**CITY OF WINTER GARDEN
DEVELOPMENT REVIEW COMMITTEE
MINUTES
July 12, 2023**

Agenda Item #3: Verax at Daniels Road – SITE PLAN APPROVAL

Agenda Item #4: 739 Vineland Office Building – SITE PLAN APPROVAL

Agenda Item #5: Stoneybrook Exchange - REZONING

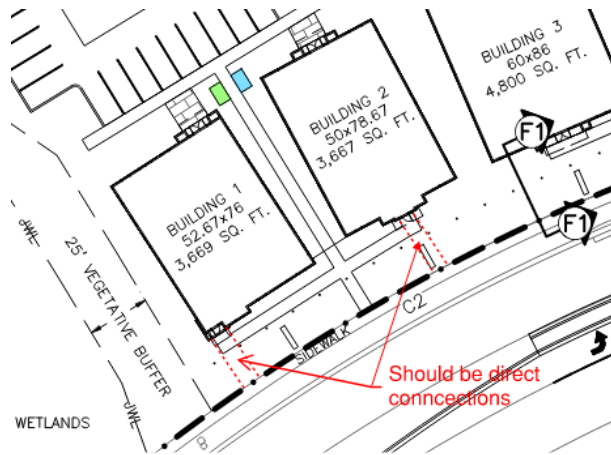
22. **A community meeting is required. This is scheduled for Wednesday, July 12th, 2023.** Applicants stated they are ready for tonight's meeting.
30. **Sidewalk connections to the right-of-way sidewalk should be direct connections (see below).** Applicants understood.
